Addendum No. 2

Issue Date: January 28, 2009

Project: 100 Bed Expansion
Mission Creek Corrections Center for Women
3420 NE Sand Hill Road
Belfair, Washington 98520
Project No. 08-303

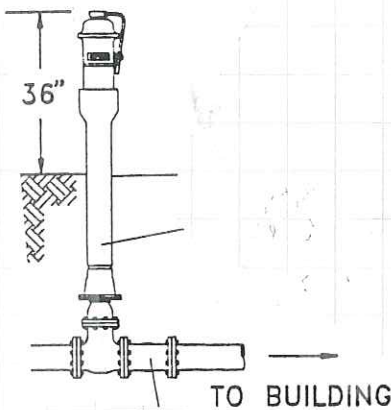
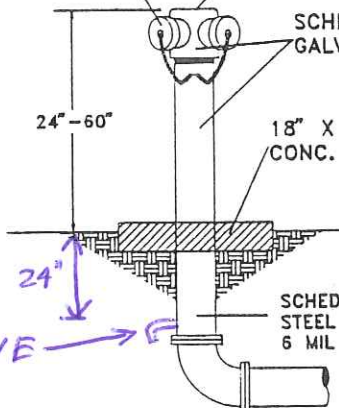
7. See attached for connection detail for the 4" PVC roof drains connecting to the 12" PVC storm drain.
8. See attached for details and specifications for FDC, PIV and associated underground fire lines.
